**RE: OWNERS CORPORATION STRATA PLAN 91174-V-RPF BUILDING PTY LTD & ANOR
SUPREME COURT OF NSW PROCEEDINGS NO. 2019/00140790**

The following Building Code of Australia Assessment Report has been prepared for the Owners Corporation of Strata Plan 91174 for the premises known as 18 Throsby Street, Wickham in order to ascertain the level of compliance with the deemed-to-satisfy provisions of the Building Code of Australia Assessment and the GHD Fire Engineering Report (Revision 2) dated February 2015 and to make recommendations for the upgrading the building to ensure compliance with these requirements.

**RE: Response to Nexus Rectification Schedule
SP91174 – 18 Throsby St, Wickham NSW**

Figure 3 Location of the hydrant booster assembly and residential carpark exits – ground floor

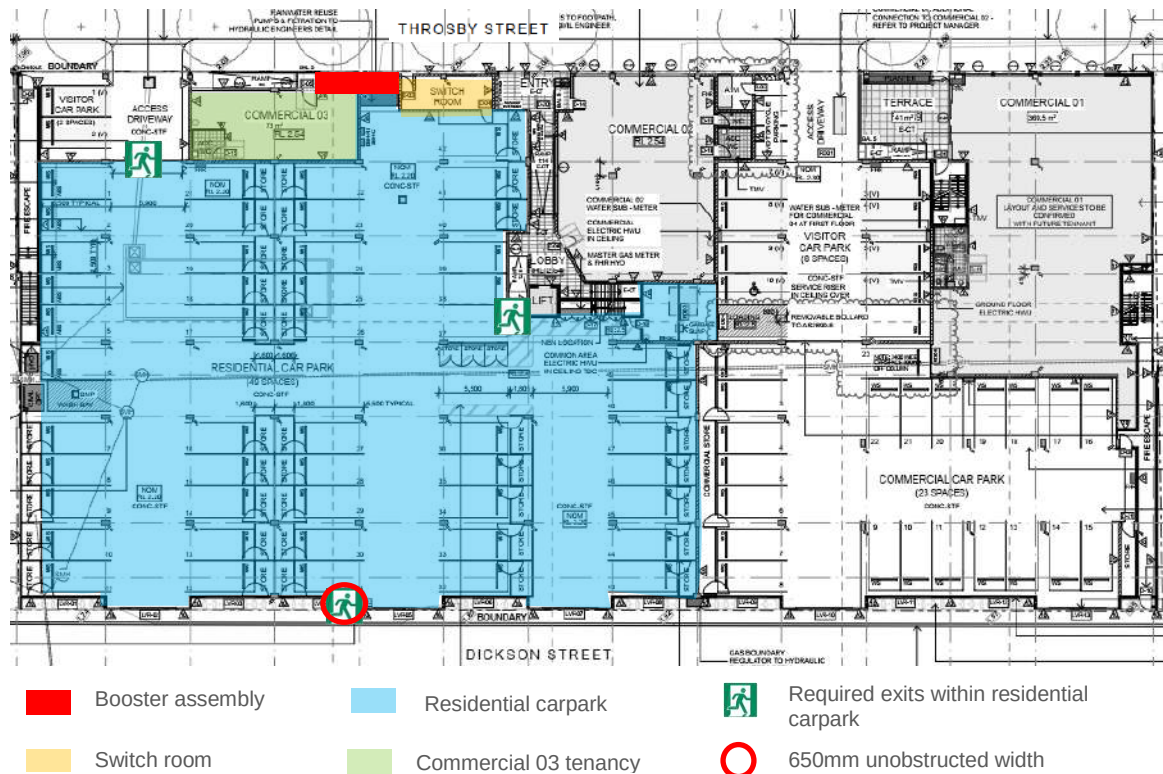
6. The southern exit doorway within the residential carpark which provides egress onto Dickson Street may have a reduced unobstructed width of 650mm instead of 750mm – refer to Figure 3.

8. A fire hydrant system must be installed throughout the building in accordance with requirements of clause E1.3 of the BCA and AS 2419.1-2005, with the exception that the booster assembly is not provided with fire rated protection extending 2m on each side of and 3m above the upper hose connections in the booster assembly. The booster assembly is located within the northern external façade of the building, adjacent to the switch room and the Commercial 03 tenancy. Refer to Figure 3.

Figure 4 Exits within the residential carpark – ground floor

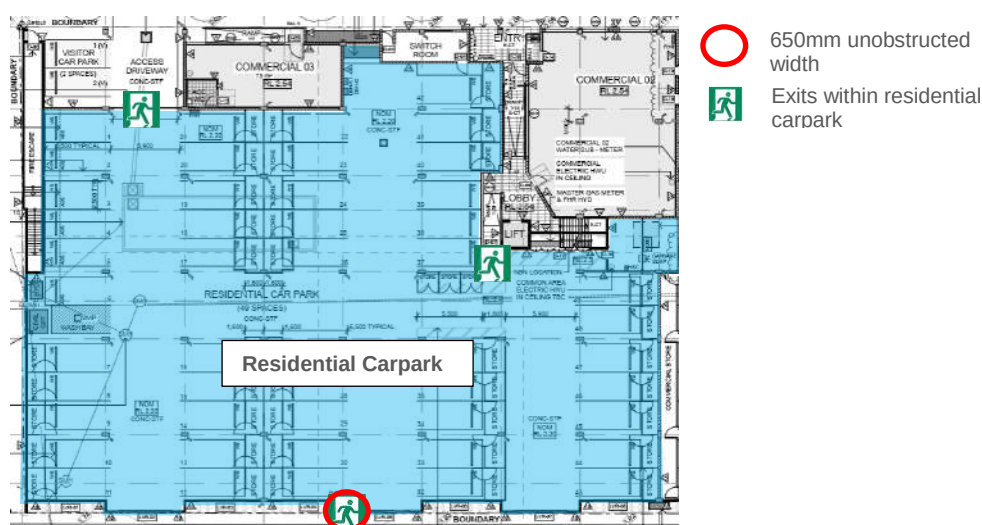
The southern exit door located on the ground floor residential carpark providing egress out to Dickson Street has an unobstructed width of 650mm instead of 750mm – refer to Figure 4.

Figure 5 Location of booster assembly – ground floor

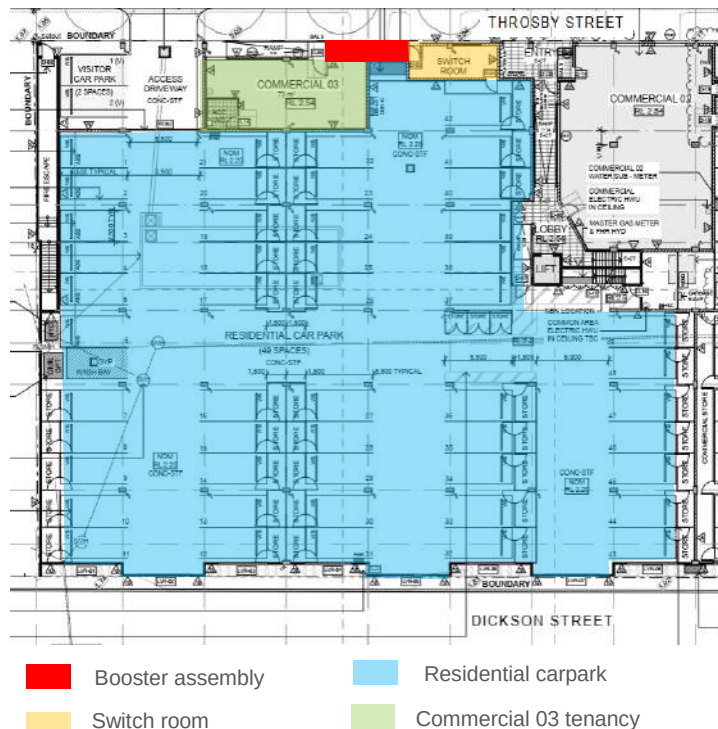
The hydrant booster assembly is not provided with fire rated protection extending 2m on each side of the suction and booster valves and for a height of not less than 3m above the upper hose connection.

The fire hydrant booster assembly is located within the northern external façade of the building, adjacent to the switch room and the Commercial 03 tenancy. To the south of the booster is the residential car park. Directly above the booster assembly on level 1 are residential sole-occupancy units Unit 4 and Unit 5. The main vehicular and pedestrian entries to the building are from Throsby Street to the north. Refer to Figure 5.
